NCPC File No. 1476

**JOHN F. KENNEDY CENTER FOR THE PERFORMING ARTS  
ACCESS IMPROVEMENTS, PLAZA AND BUILDINGS**

May 27, 2004

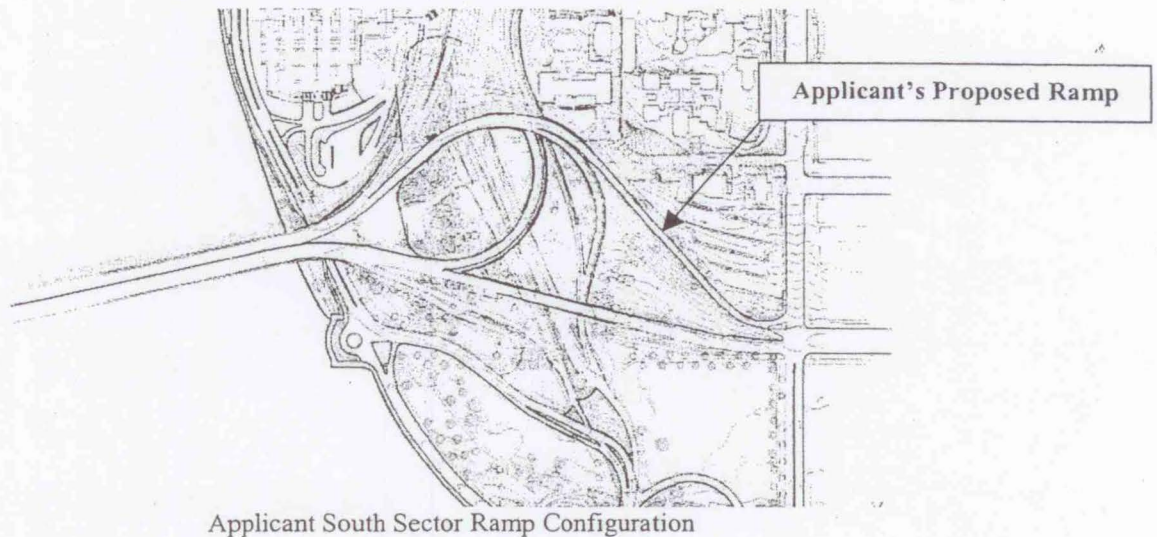
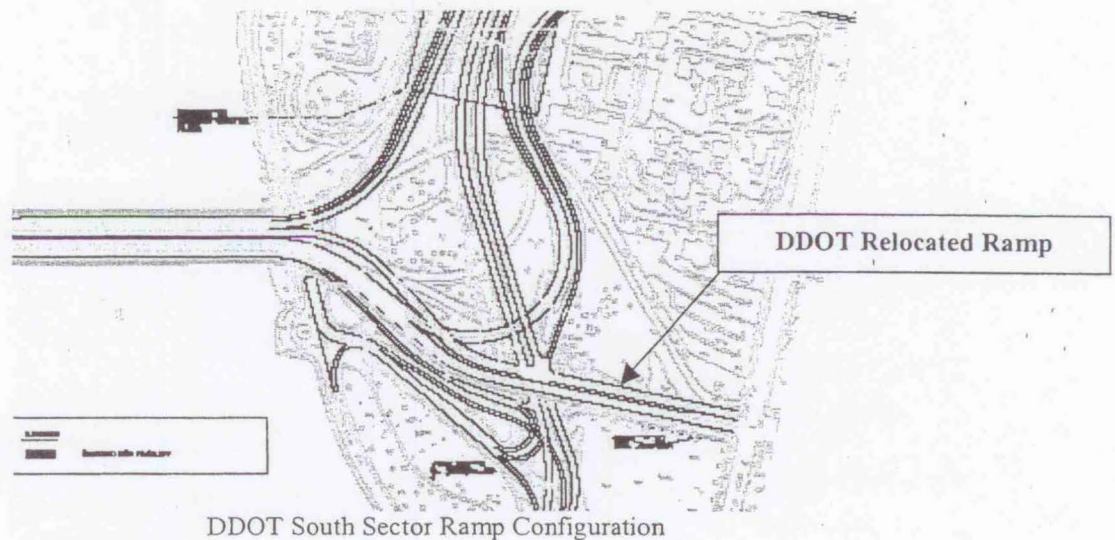
same function. Staff is troubled by this element of the project. The project goals include relieving congestion at the intersection of Virginia Avenue, NW and the Rock Creek and Potomac Parkway, yet the very ramp connections that are causing this congestion are being retained. The applicant states that these ramp connections are necessary to serve traffic moving between K Street, NW and the Potomac Freeway, and that such traffic will not be able to use the new direct connection between the Rock Creek and Potomac Parkway and the Potomac Freeway. Staff is concerned that retaining the ramps that connect 27<sup>th</sup> Street, NW to the Potomac Freeway will result in continued traffic congestion on Virginia Avenue and requests that the applicant explore other options to serve the traffic moving between K Street and the Freeway.

As the north sector design proceeds, the project design must be coordinated with the District Department of Transportation (DDOT's) plans for modifying the Whitehurst Freeway. DDOT is just beginning a study of major modifications to the Whitehurst Freeway. The design of project roadways in the north sector may be required to change based on DDOT's developing plans for the Whitehurst Freeway.

The applicant proposes major construction in the north project sector, including significant grade changes. The District of Columbia Office of Planning wishes to explore future reconnection of the city street grid in this area. Staff requests that the applicant verify that the proposed north sector project improvements will not hinder reconnecting the street grid in the future.

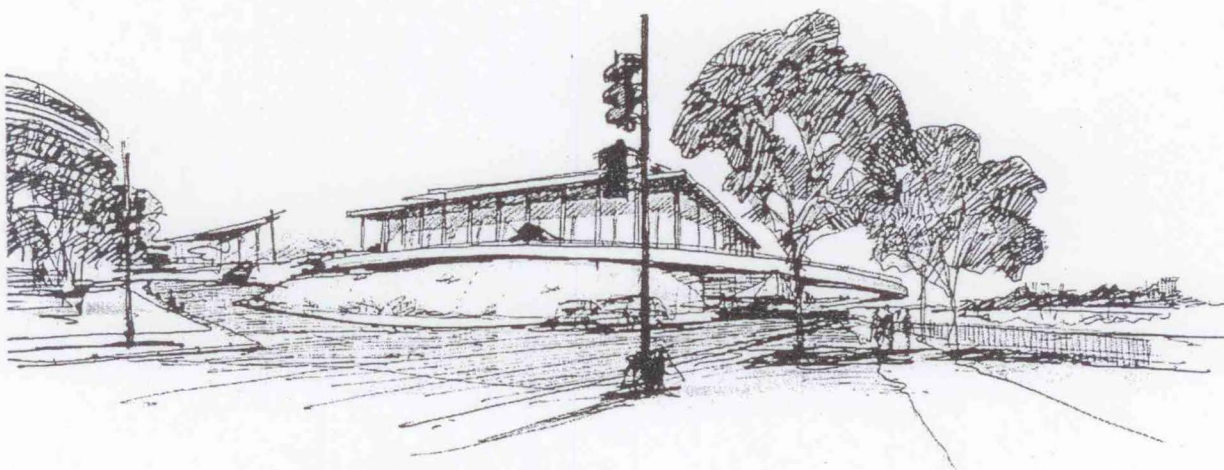
1. The scale of the plaza may siphon off pedestrian activity.
2. The lack of a central focus to the plaza and creation of many individual pedestrian spaces may siphon off pedestrian activity. Because of its size, the plaza is broken into smaller public spaces separated from one another by the roadways that serve drop-off and parking areas. The amphitheater is isolated from other pedestrian space in the plaza by surrounding roadways.

3. The focus on auto movements through the space and the potential difficulty of pedestrian crossing of roadways in the space may impact pedestrian use of the space. The large triangular water feature at the east side of the plaza limits pedestrian movement.
4. The indirect nature of the connection between the plaza and 25<sup>th</sup> Street, NW may discourage pedestrian movement from Foggy Bottom/West End into the plaza, including pedestrian movement from the Foggy Bottom Metro station.
5. The relative isolation from other uses is likely to contribute to the possibility that it will be underutilized, in spite of programming planned by the Kennedy Center.
6. The water feature between E Street and the plaza is very large and its shape may preclude any winter time use.

The plaza design should be reconsidered in light of the above concerns to create a smaller, more intact, more comprehensive, pedestrian-oriented space with improved connections to the north.

Proposed Bicycle Trail between 23<sup>rd</sup> Street, NW and Kennedy Center Plaza

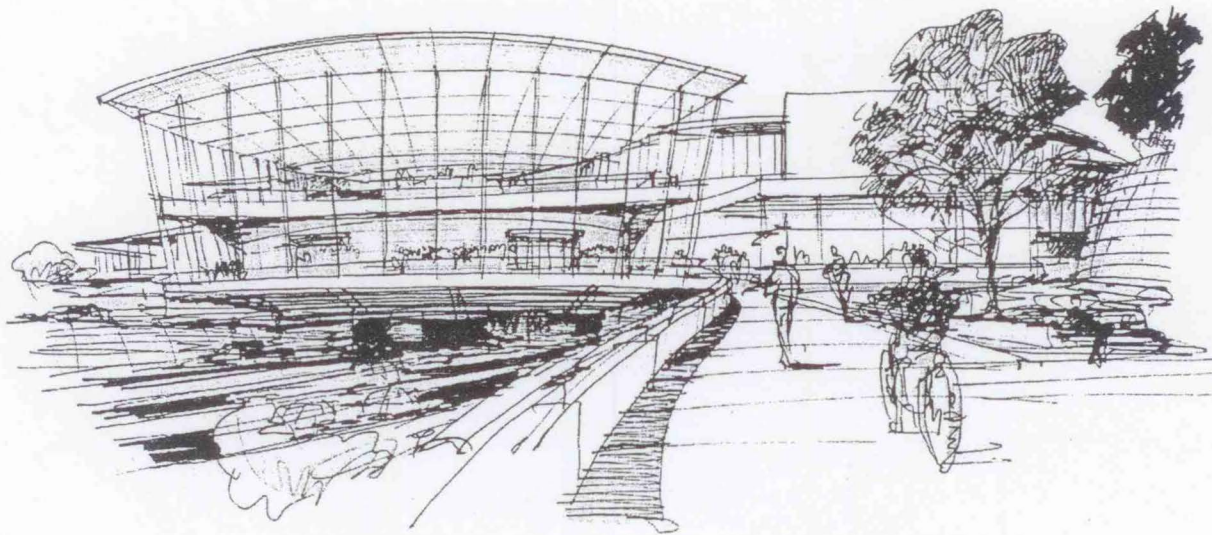
Although the applicant proposes significant pedestrian access improvements by way of a new surface level E Street and the various public spaces planned for the plaza, staff finds the project needs greater focus on accommodating pedestrian movement as the design develops further. Specifically, staff recommends better pedestrian connections to the north, including the Foggy Bottom and West End neighborhoods and the Foggy Bottom Metro station as well as better pedestrian connectivity among the various buildings and public spaces planned in and around the plaza. Pedestrian-vehicle conflicts at the plaza level must be resolved in favor of pedestrian movement.

Old Naval Observatory overlooking Center Project Sector

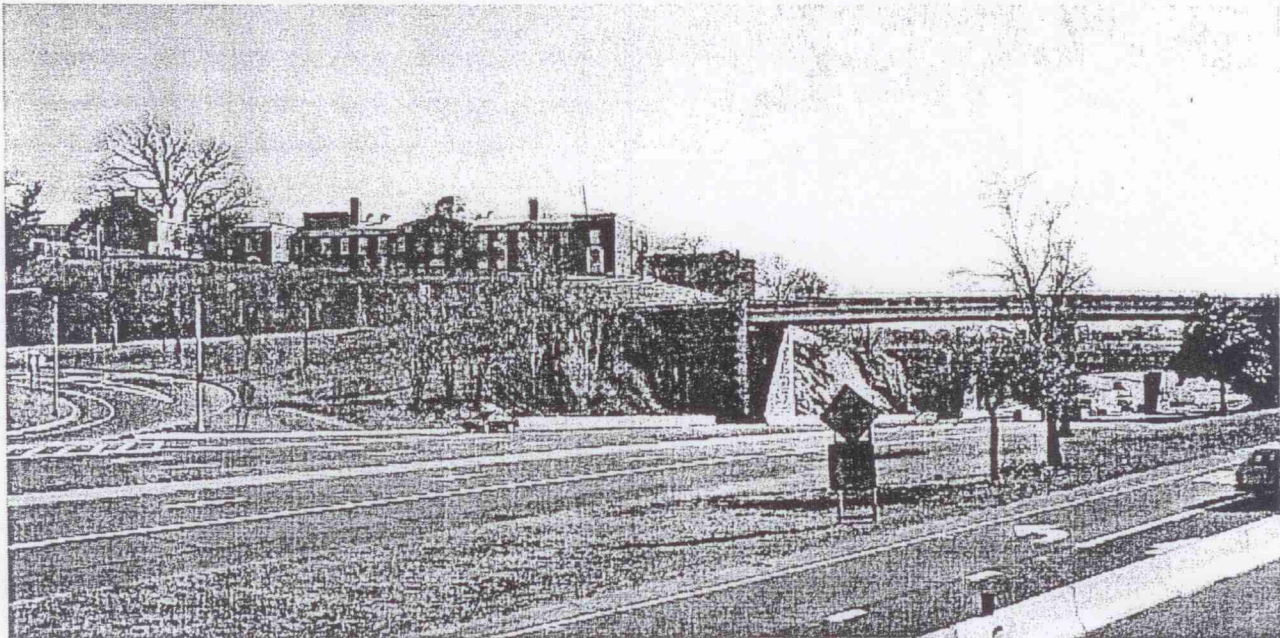
As project design proceeds, the applicant must consider the perimeter security requirements of the Old Naval Observatory site and assure that the project design does not have a negative impact on that facility.
